Steven H. Emerman, Ph.D.

June 17, 2021

I understand your question to be the following: Does the discovery of this additional blocked stormwater pipe affect the validity of either the Seamon-Whiteside or the AECOM stormwater models? In other words, do either the Seamon-Whiteside or the AECOM stormwater models include this pipe and assume that the pipe is unblocked?

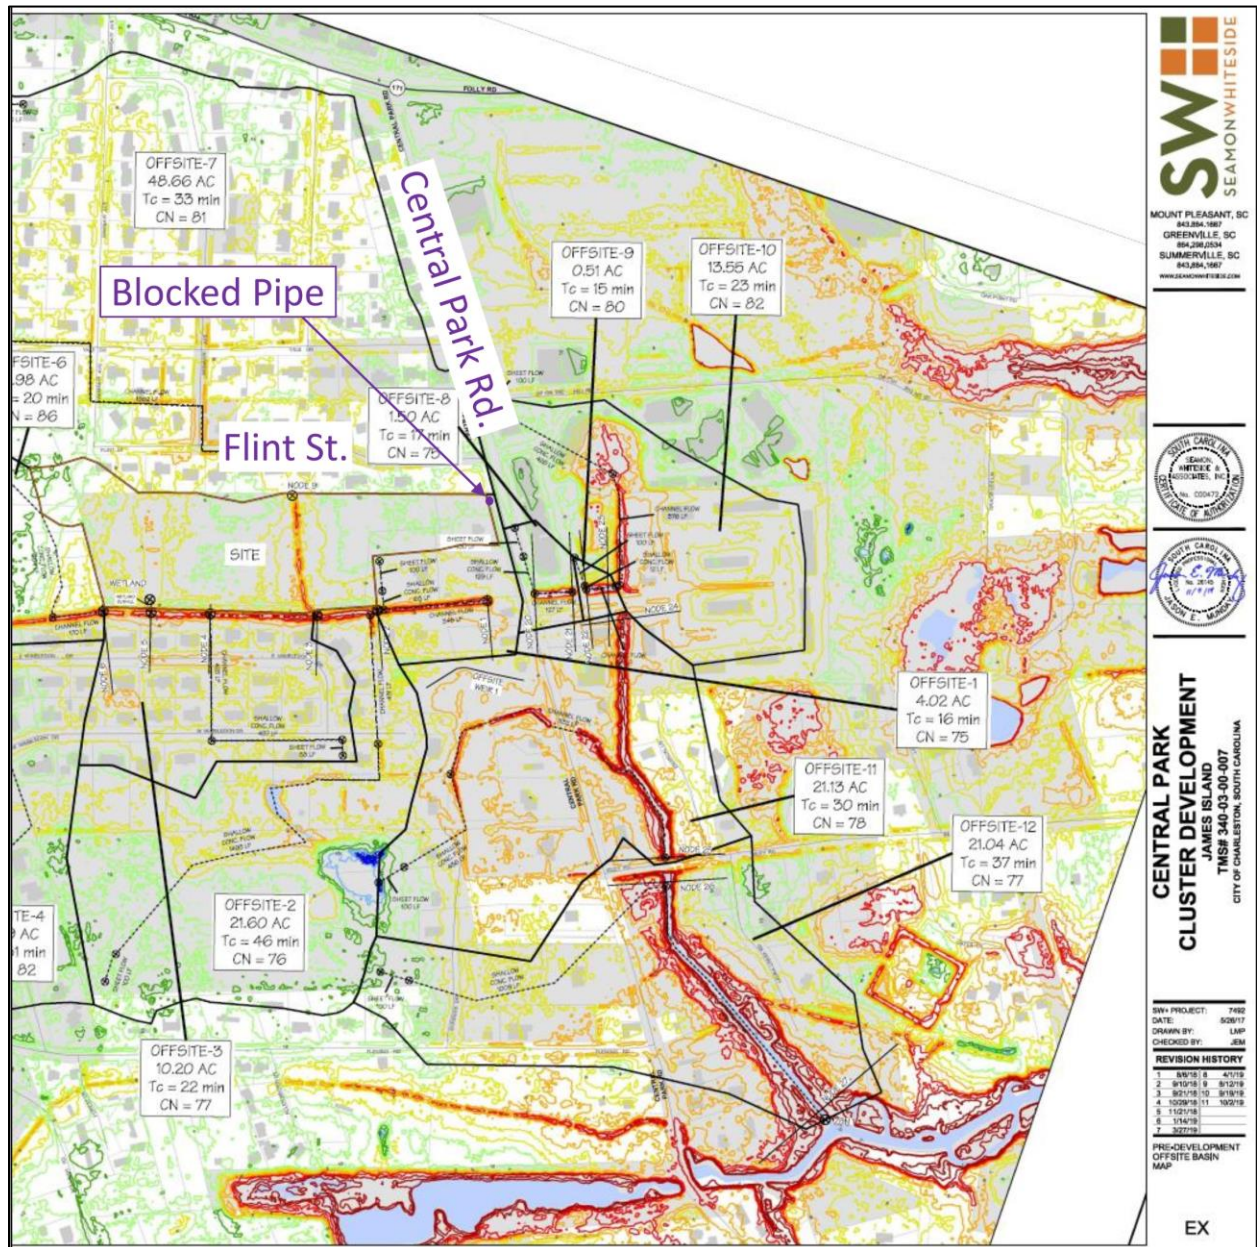
- 1) The stormwater models by Seamon-Whiteside and AECOM do not include the existence of the 18-inch stormwater pipe shown in Figs. 1-2. Therefore, their model outputs would not be changed in terms of whether the pipe is blocked or unblocked.

- 4) Based on the elevation contours, the 18-inch stormwater pipe shown in Figs. 1-2 ought to be within the pre-development drainage basin boundary.
- 5) The fact that the Seamon-Whiteside model did not include the 18-inch stormwater pipe shown in Figs. 1-2 further emphasizes the inaccuracy of the model.

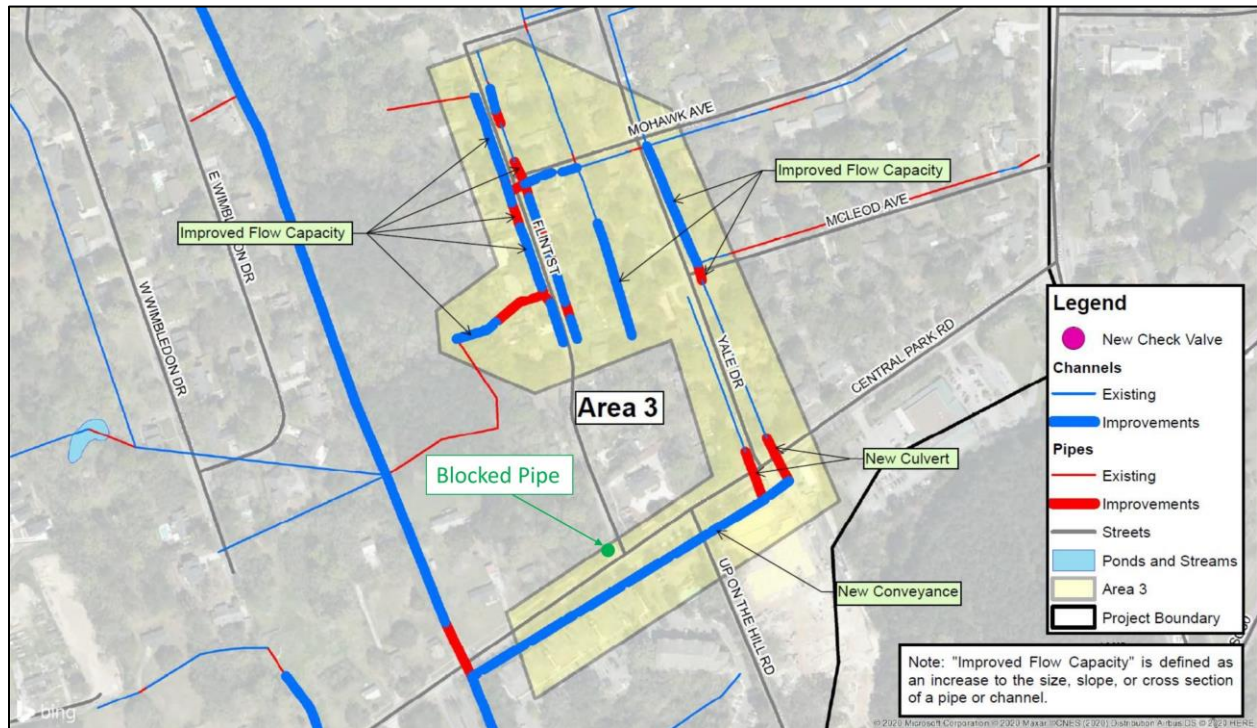
The blocked stormwater pipe is not shown on the stormwater infrastructure drawings for either the Seamon-Whiteside stormwater model (see Figs. 3a-b and 4) or the AECOM stormwater model (see Fig. 5). For that reason, the fact that the 18-inch stormwater pipe is currently blocked would not affect the output of either the Seamon-Whiteside or AECOM model because those models do not include that particular pipe, either blocked or unblocked. In fact, according to the drawings for the Seamon-Whiteside model (see Figs. 3a-b), the blocked stormwater pipe is outside of the pre-development drainage basins for the proposed Central Park development, so that the stormwater pipe should be irrelevant for drainage into or out of the site of the proposed development. Note that the drainage flow arrows in Fig. 3a point to the west (toward the lower left corner of the figure) and away from the location of the blocked pipe. It is not clear why the AECOM stormwater model, which covers a much greater area (see Fig. 5), does not include the blocked stormwater pipe, since, presumably, the pipe has not always been blocked and does not appear to be sealed or permanently blocked.

On the other hand, it is not clear why the Seamon-Whiteside model does not include the blocked stormwater pipe. The Pre-Development Drainage Map (see Figs. 3a-b) includes light gray surveyed contours that indicate stormwater flow to the ENE subparallel to Central Park Road and across the pre-development drainage basin boundary in the direction of the blocked stormwater pipe. Fig. 3a shows the contours without the drainage direction labeled, while Fig. 3b shows the drainage direction overlain on top of the contours. On that basis, the pre-development drainage basin boundary and the surveyed contours are inconsistent. In fact, the logic behind the

Figure 4. A portion of the Pre-Development Off-Site Basin Map from the document by Seamon-Whiteside entitled “Drainage Report for Central Park Cluster Development” does not show the blocked 18-inch stormwater pipe (see Figs. 1-2). All additional information on the map (street names and blocked pipe location) is in amethyst. The map does not include a legend, scale bar or north arrow. The north arrow should probably be the same as in Figs. 3a-b.
